Addendum # 1
Bid Opportunity: 24-7512-RFT - Courtland Public
School HVAC Upgrades
Closing Date: Tuesday, April 2, 2024 2:00 PM

PROJECT NAME
COURTLAND PUBLIC SCHOOL HVAC UPGRADE
 107 COURTLAND AVE. E., KITCHENER, ON. N2G 2T9

DRAWING TITLE
**TECH. ROOM 20A
FINISHES & REFLECTED
CEILING PLANS**

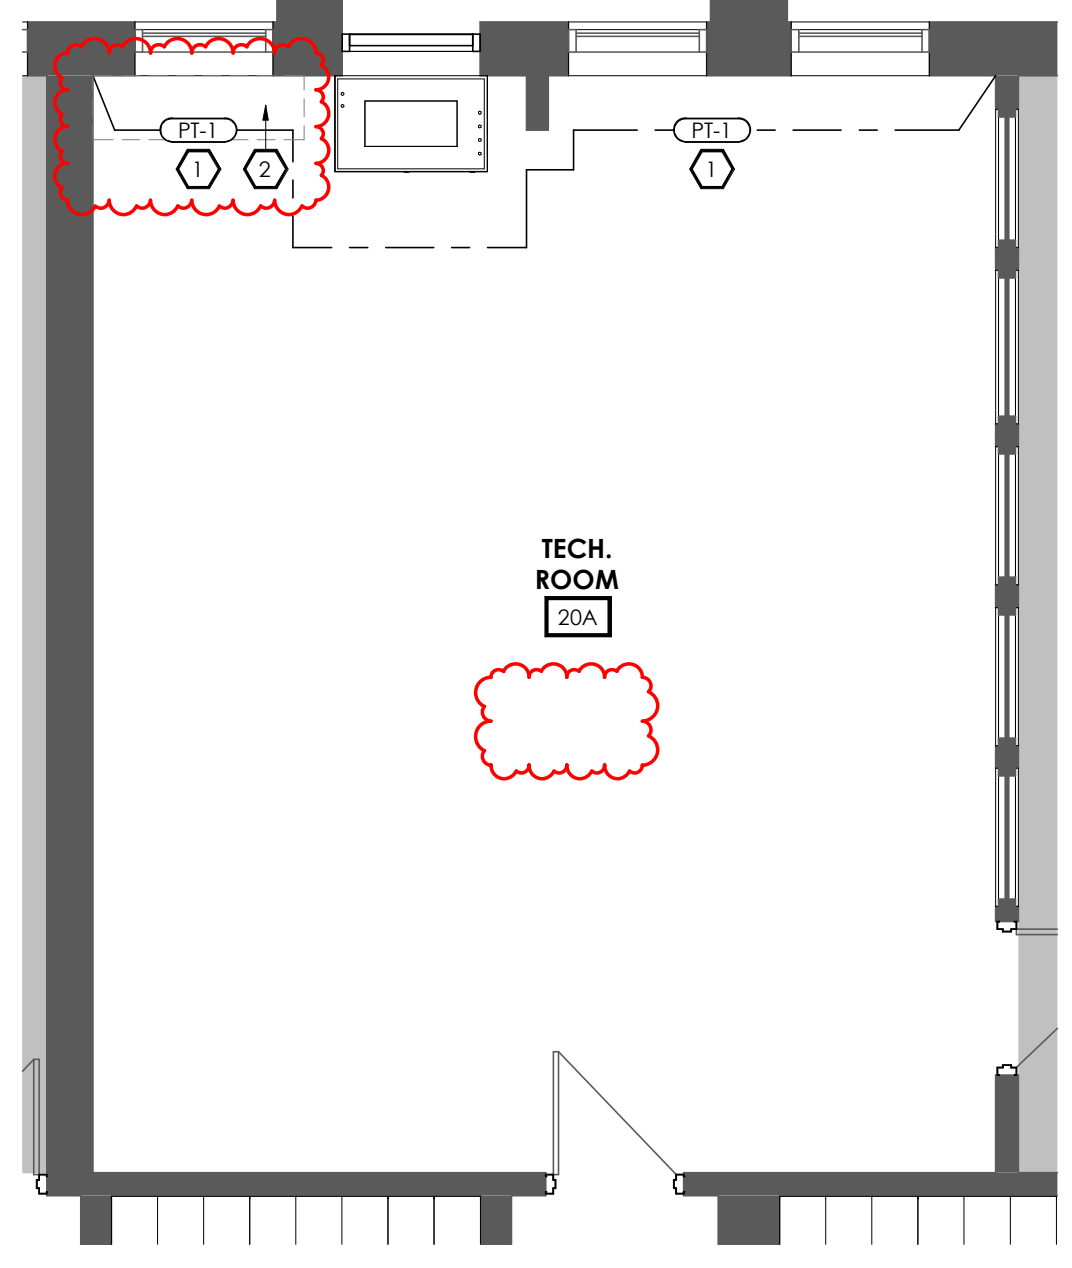
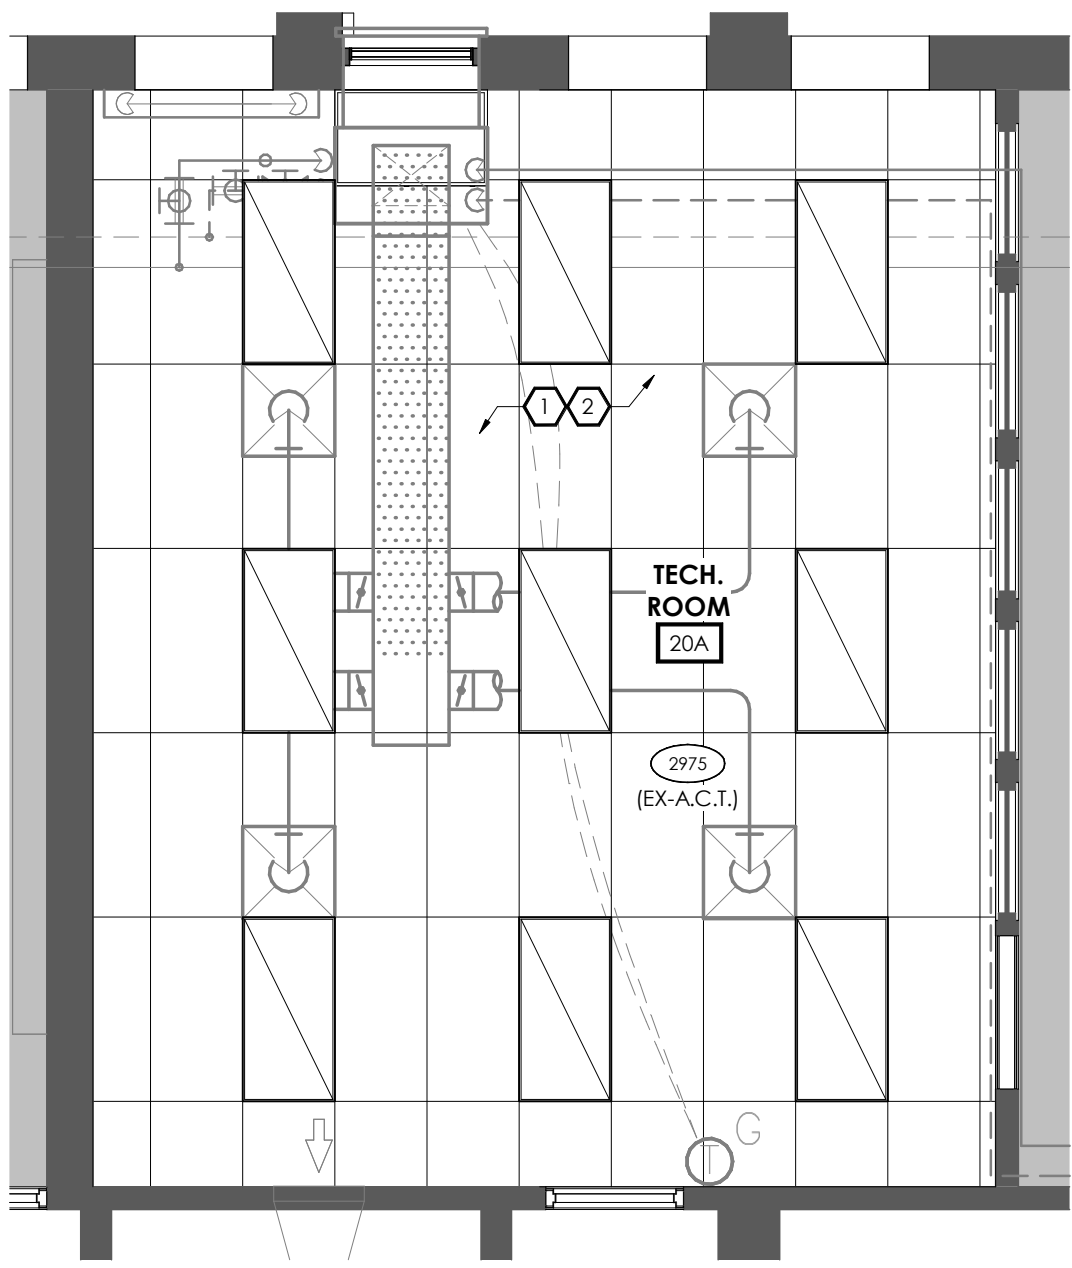
Refer to attached updated finish plans for appropriate amount of flooring to be replaced if damaged. Refer to Resilient Flooring specification.

DRAWING TITLE
**FIRST FLOOR
 DEMOLITION PLAN**

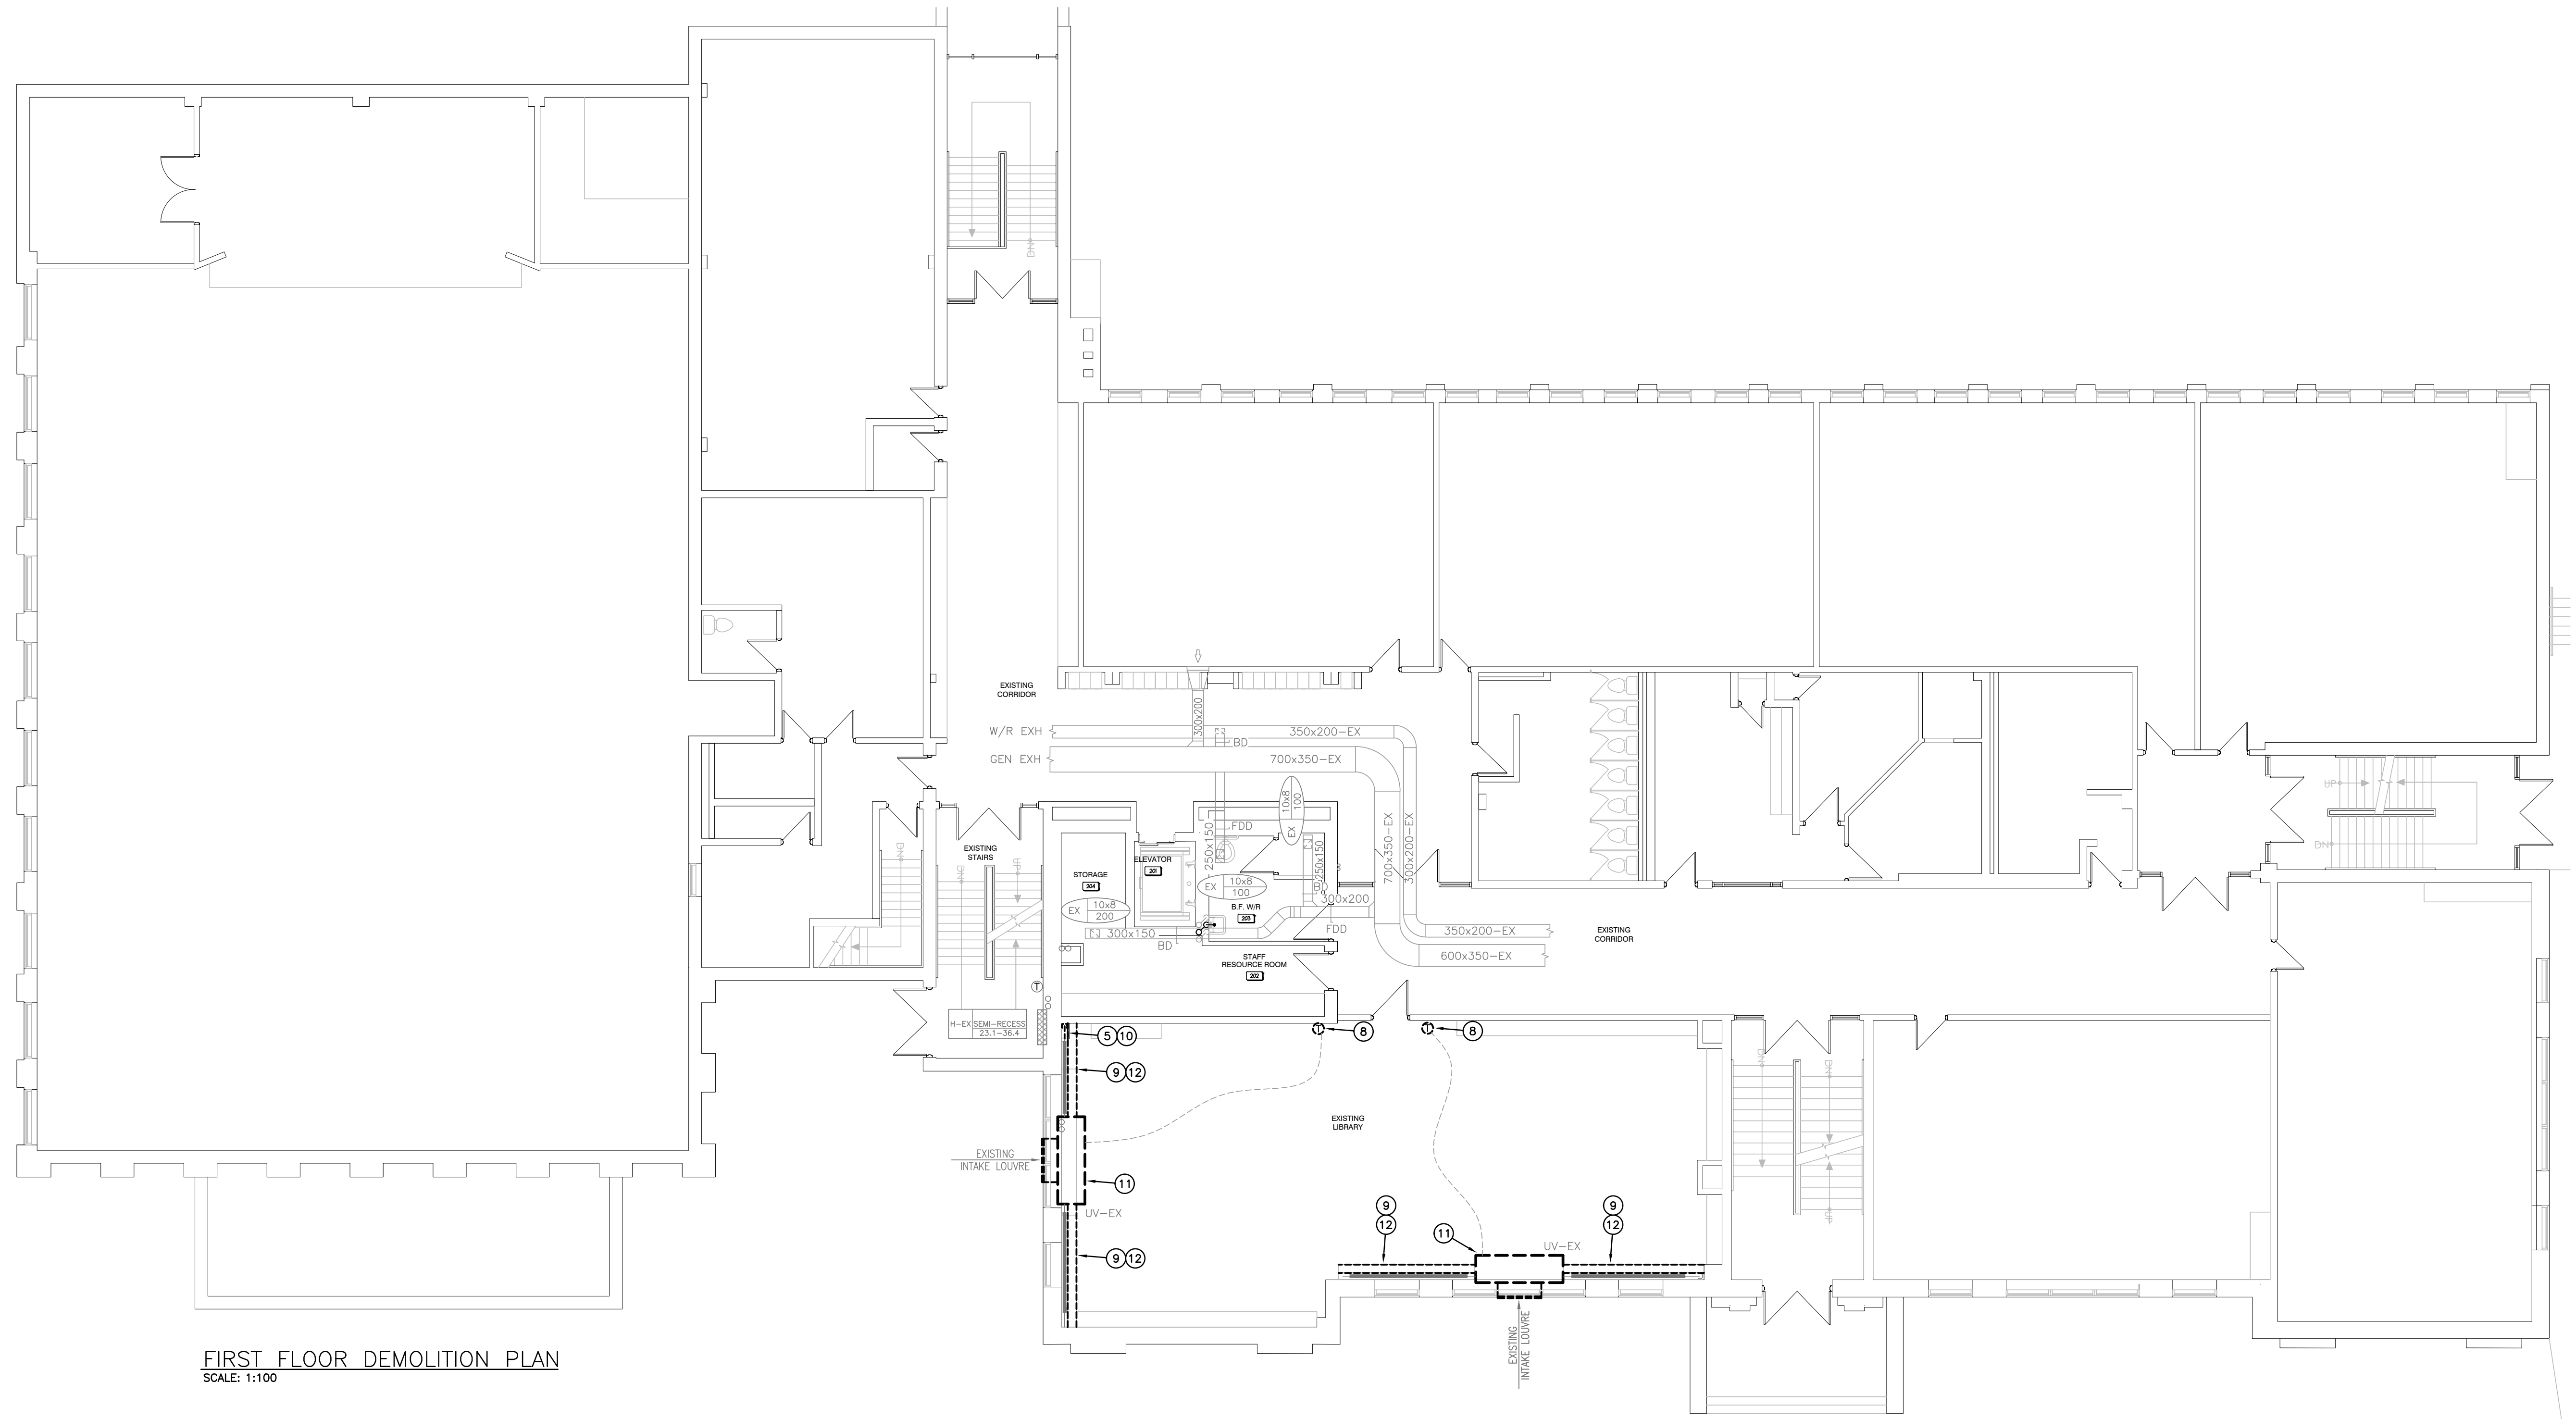
- 2.0 Reference Attached Reissued Drawings M2.2 and M3.3
- .1 Remove Note 13 from drawing M2.2. No demo work required in BF Washroom 42.
 - .2 No new work required in BF Washroom 42.
 - .3 Condensate for UV-5 and UV-6 to discharge through exterior wall.

**GROUND FLOOR
HVAC RENOVATION
PLAN**

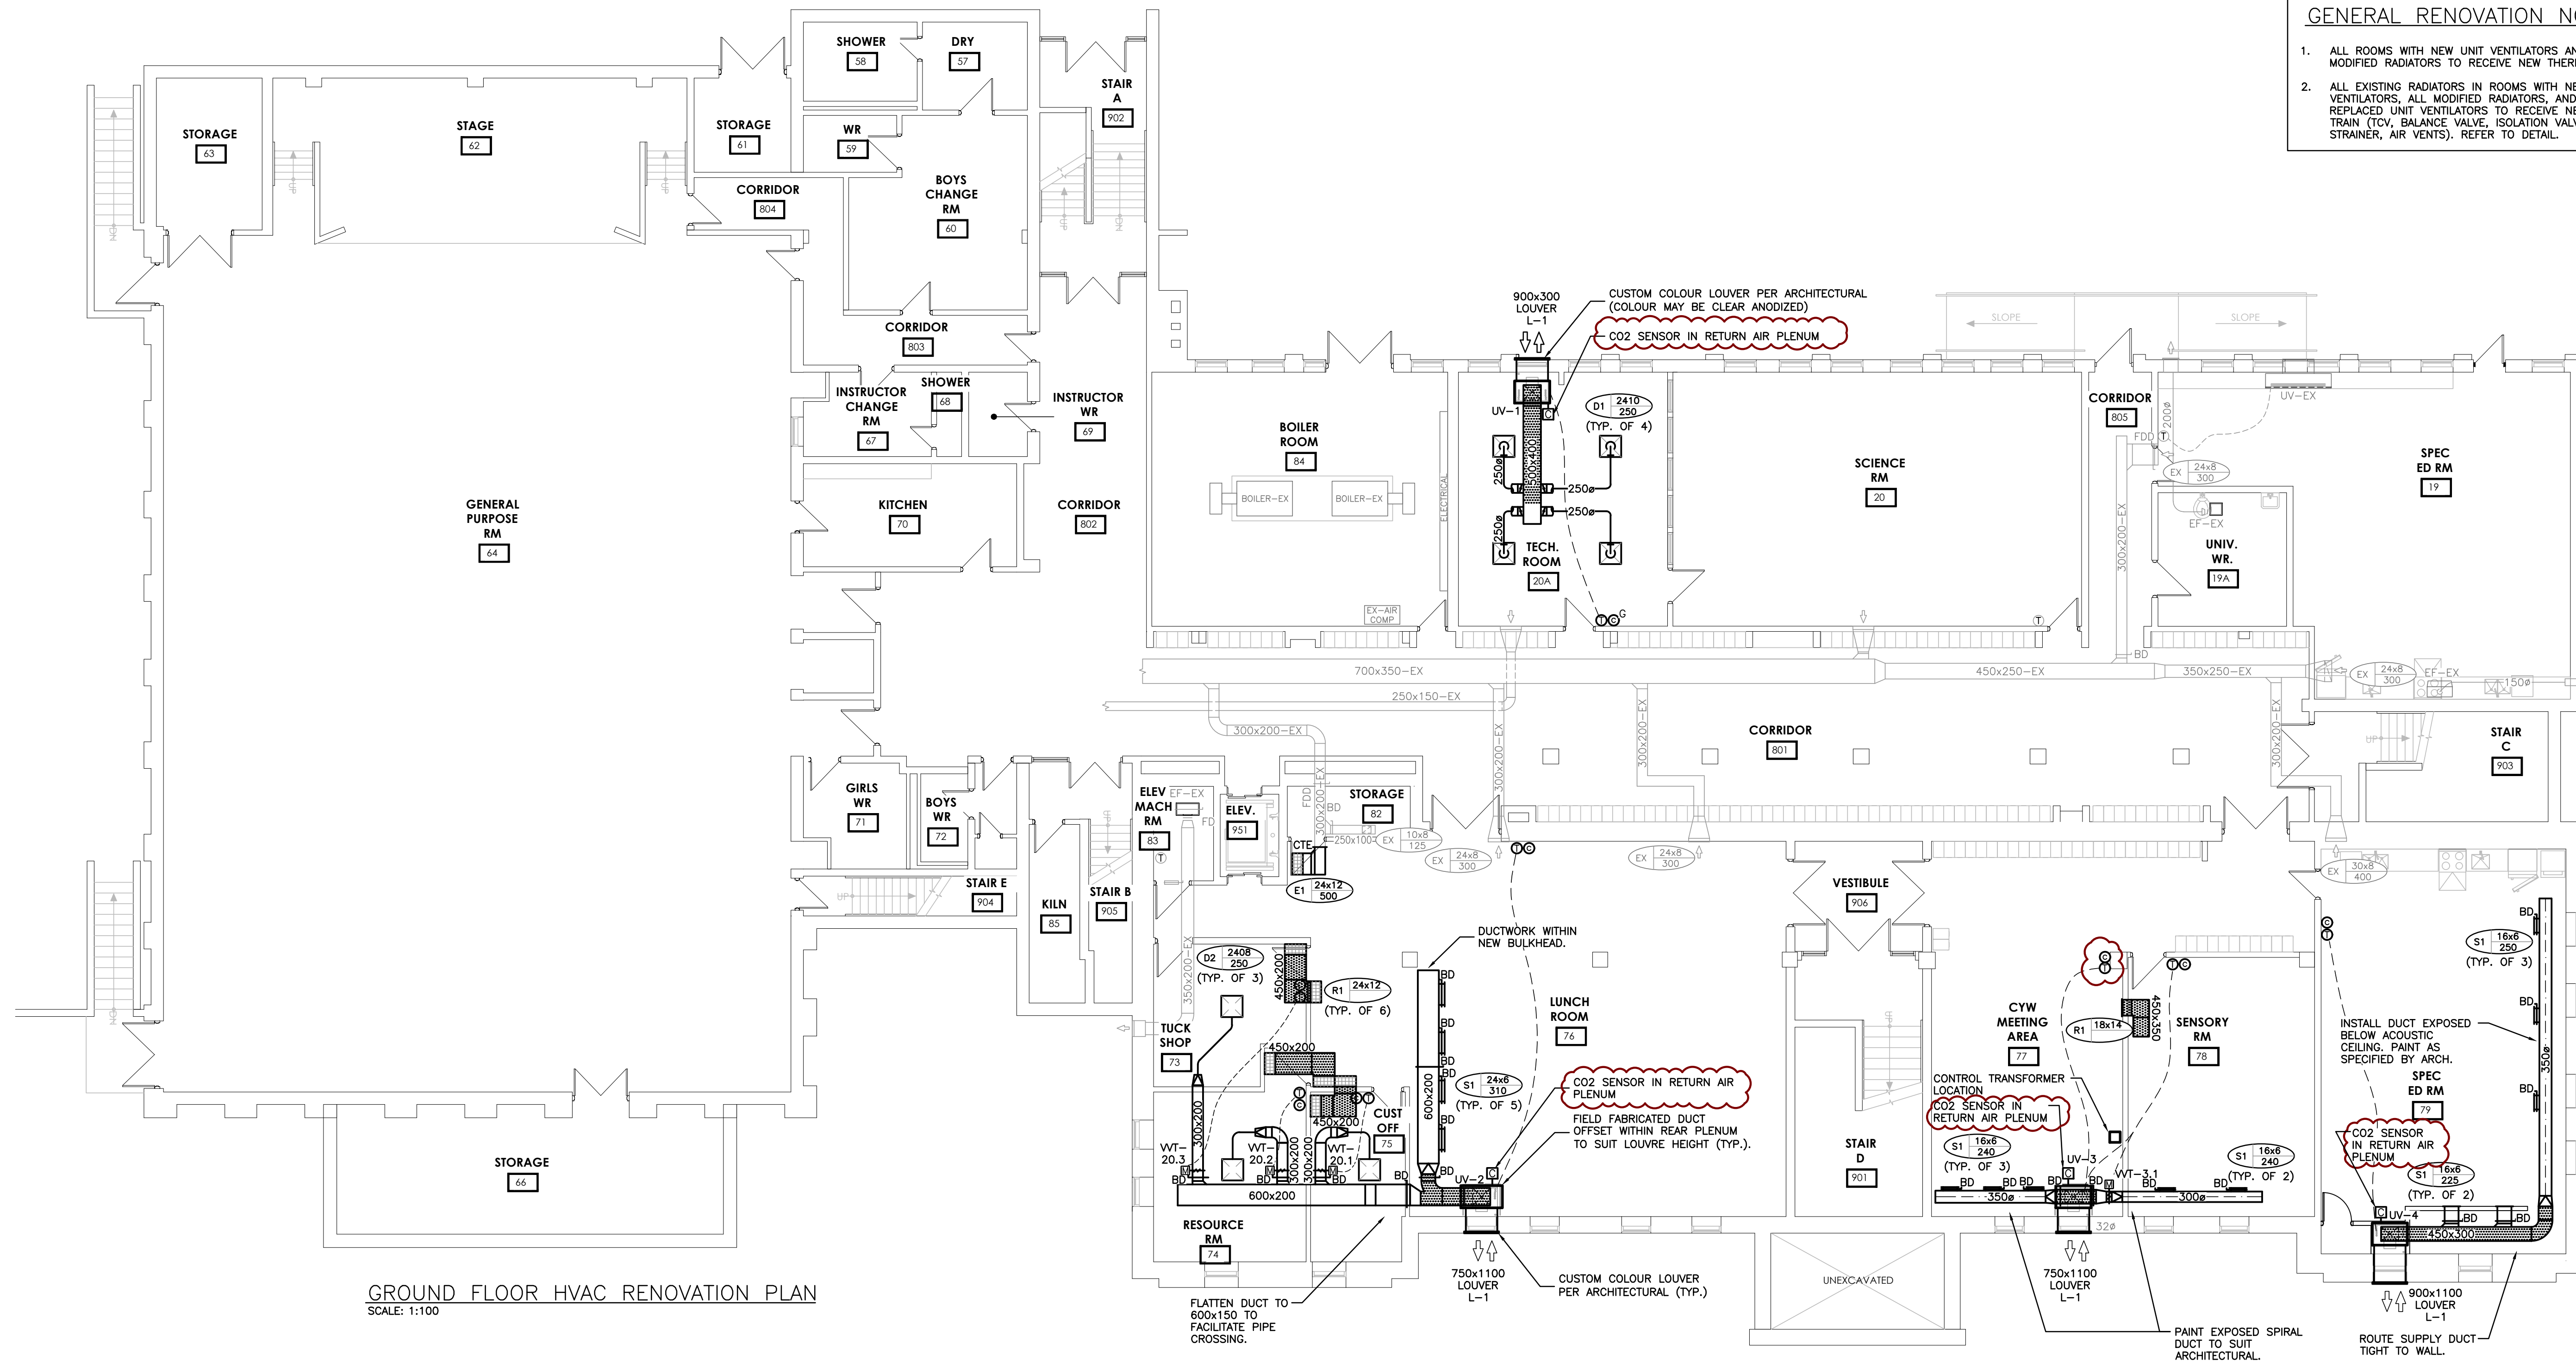
- 1.0 Reference Attached Reissued Drawings M1.1 and M3.2
- .1 Minimum outdoor airflow rate for unit ventilators to be revised as indicated.
 - .2 Minimum static pressure for ducted unit ventilators to be revised to 0.5" w.c.
 - .3 Provide CO₂ sensor in return air plenum for monitoring by BAS system.
 - .4 A 'C' in circle (beside a thermostat) represents a wall mount CO₂ sensor.
 - .5 Unit ventilator numbering is to be updated to continue sequentially after existing unit ventilator numbering. Numbering will be updated after award of tender.
